ADDENDUM NO. 3 - OUTLINE AND SUMMARY INFORMATION

Project Name: Classroom Improvements 2025-2026
Location: Montana State University - Bozeman

PPA No.: 25-1214
Date: January 30, 2026

126 INTERIOR
ELEVATIONS
ALT. #4

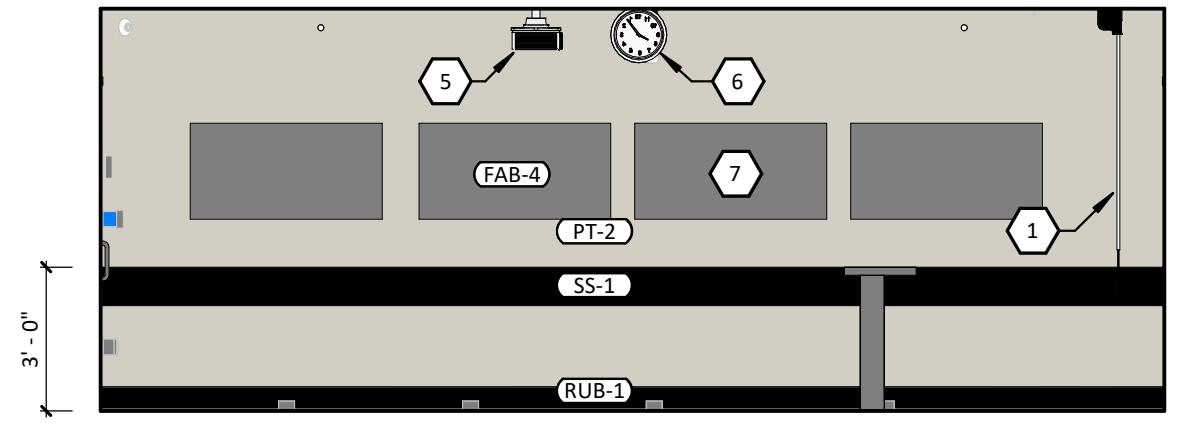
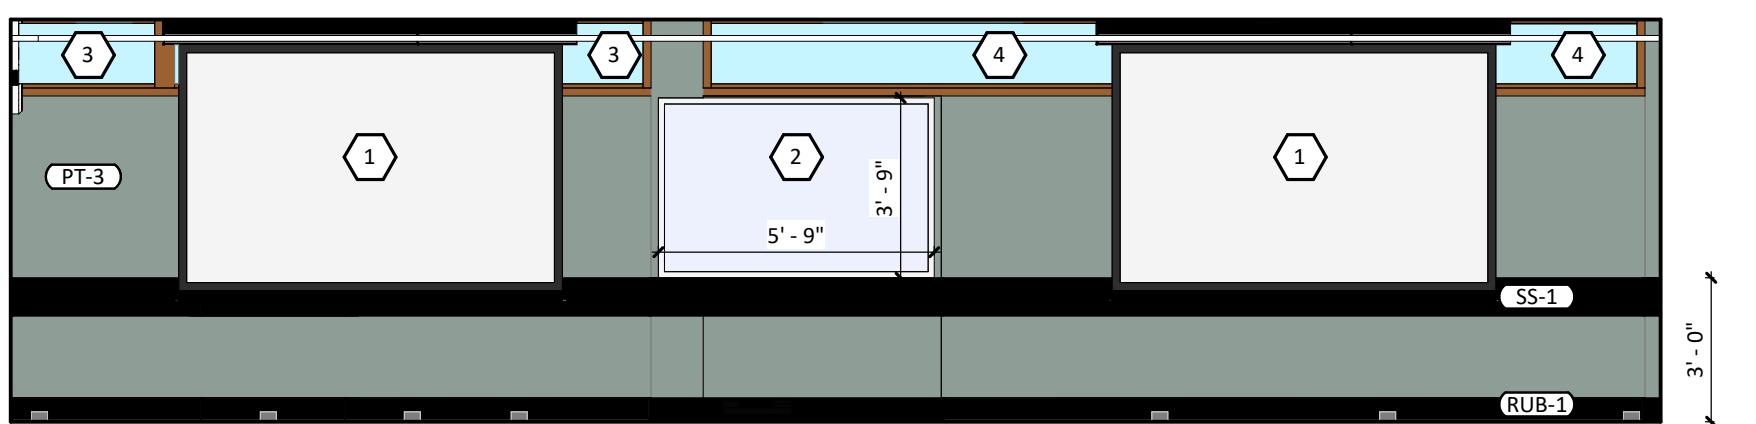
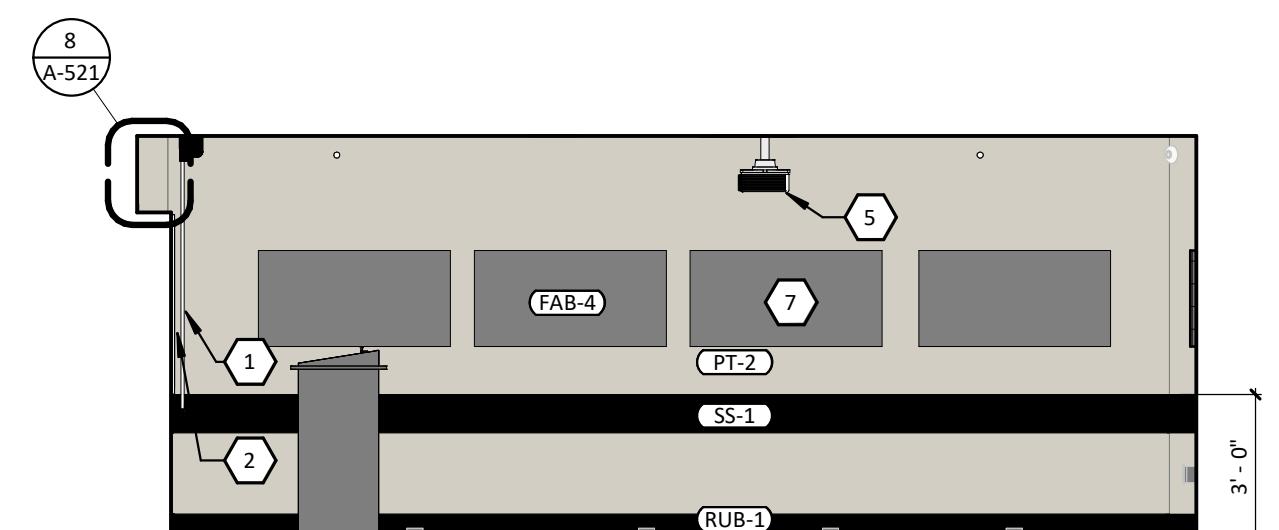
1. There is no indication of glass type in either the plans or specs, just a section on 2/A-124 that calls for Double pane acoustic glazing. Please provide glazing schedule. Please confirm this glazing applies to both add alt #3 and add alt #4.
 - o **Response:** See revised 1/A-215. Detail 2/A-124 applies to Alternate #3 only.
2. There is no fire rating callout on the door schedule; please confirm if these doors are rated. And if so, please specify required fire rating.
 - o **Response:** Thank you for bringing this to our attention. See revised sheet A-601 for clarity on the door fire ratings.
3. Keynote #4 on A-215 is calling for existing glazing and frame to remain. I assume that this is carryover from the previous elevation sheet, but please confirm this note should be ignored, with a new storefront frame and glazing in this location.
 - o **Response:** See revised 1/A-215.

4. Keynote #8 on A-215 is calling for a Kawneer 451 UT storefront system. Per the manufacturer's website the 451UT Framing System is "engineered for the most demanding thermal performance by employing a "dual" thermal break". Please confirm that a non-thermal system is acceptable, being that this is an interior storefront frame.
 - o **Response:** The Kawneer Trifab VersaGlaze 450 framing system is an approved alternate to the 451UT system and is a non-thermal system.

1. A-215 Alternate #4 shows storefront that is not currently in place. These are marked with note #4 "EXISTING GLAZING AND FRAME TO RAMIN" or not labelled. The window schedule does not show frame profiles that would match these. There is no Demo plan for Alternate #4 for additional wall demolition for the larger windows.
 - o **Response:** See revised 1/A-215.
2. Detail 2/A-124 shows double pane acoustic glazing in the windows that are to be installed in existing frames. Please confirm this is not to be $\frac{1}{4}$ " clear to match the other existing windows.
 - o **Response:** Double pain acoustic glazing is confirmed. Detail 2/A-124 applies to Alternate #3 only.
